**Interim Verification Report
Investigation of
Peoples Gas Pipeline Safety Program**

Illinois Commerce Commission

June 22, 2009

III-17

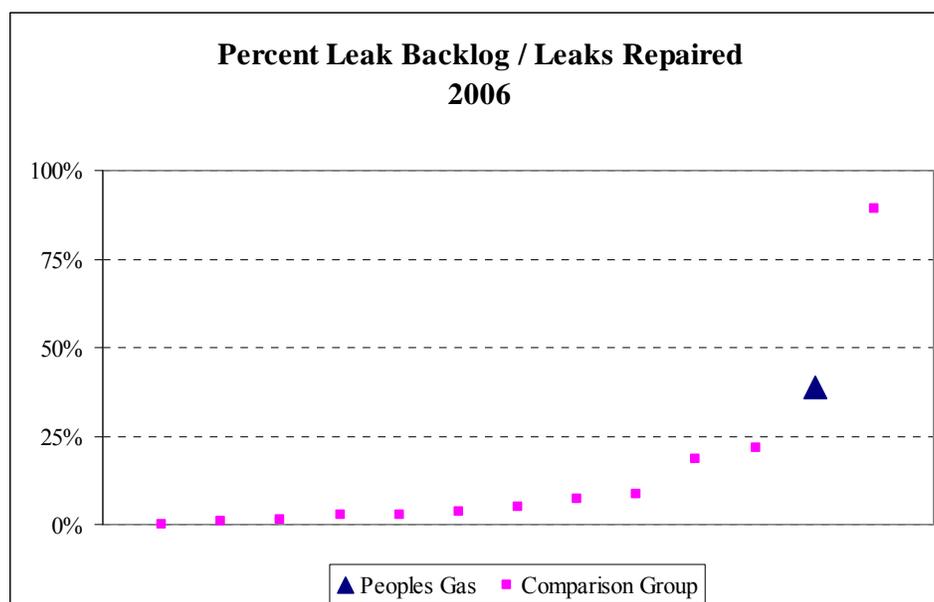
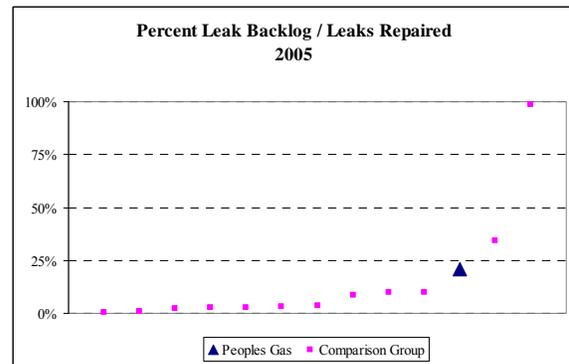
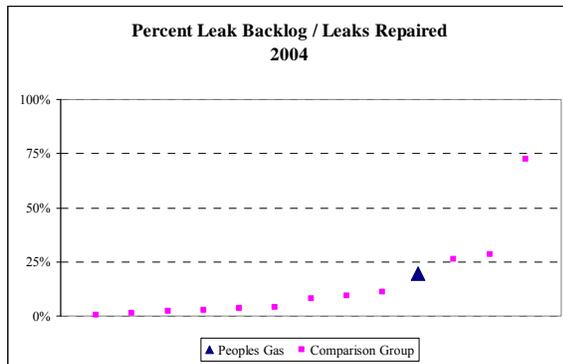
Peoples Gas needs to repair more leaks and reduce the level of backlogs at year-end. In both relative terms, compared to its peers, and absolute numbers of leaks outstanding, Peoples Gas' leak backlog is too high. Peoples Gas should reduce the backlog so that the percentage of the leaks in backlog at year-end is less than 10 percent of the number of leaks repaired during the year. Peoples Gas should develop and implement a written plan for meeting this recommendation. The plan should include specific goals for reducing leak backlogs and repairing more leaks, including target levels for leak backlogs at year-end for the current and following two years.

Peoples Gas has had a comparatively large leak backlog at year-end, a time of year when frost cover presents the highest risk for hazardous gas leak migration. Peoples Gas carried over 500 leaks in need of repair at year-end 2005. This level of backlog is high in relation to the number of leaks repaired.

This metric compares the leak backlog with the actual leak repair efforts. The charts below show the number of known leaks at year-end scheduled for repair as a percentage of the total number of leaks repaired during the year. A higher number reflects poor repair numbers compared with leak backlogs. An acceptable performance number is in the low single digits.

- Provide copy of November 19, 2008, report on Status of Leak Indications by November 21, 2008. This schedule is consistent with Liberty's recommendation that Peoples Gas should develop a plan within three months of the date of Liberty's final report.

- Continue this rate of leaks repaired versus leaks received (110%) through the end of 2009.
- Achieve a reduction in the backlog so that the percentage of leaks in backlog compared with leaks repaired by year-end 2009 is below 10 percent. (Note that this differs from the response to Data Request 327, which identifies the year-end 2009 goal as 14 percent. Actual for year-end 2008 was 17.7 percent).
